PRODUCT CHANGE NOTIFICATION

Bourns® Model SRR1206-151KAL Shielded Power Inductor

Manufacturing Process Change

IC2098

Existing Manual Glue Dispensing Process

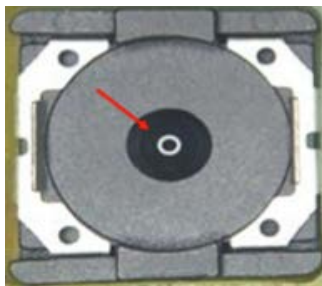
Glue at center of inductor mounting platform

Revised Automated Glue Dispensing Process

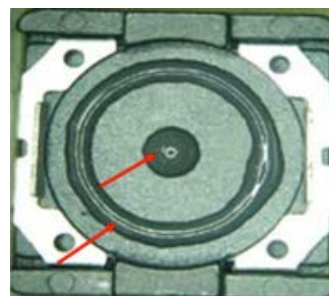
Riverside, California – October 16, 2020 – Effective January 16, 2021, Bourns will change the manufacturing process for the Model SRR1206-151KAL Shielded Power Inductor from manual glue dispensing on a mounting platform to an automated dispensing process. This change should improve the quality and reliability of the inductor, while at the same time increasing Bourns’ productivity in the manufacture of the inductors.

Glue at center and perimeter of inductor mounting platform
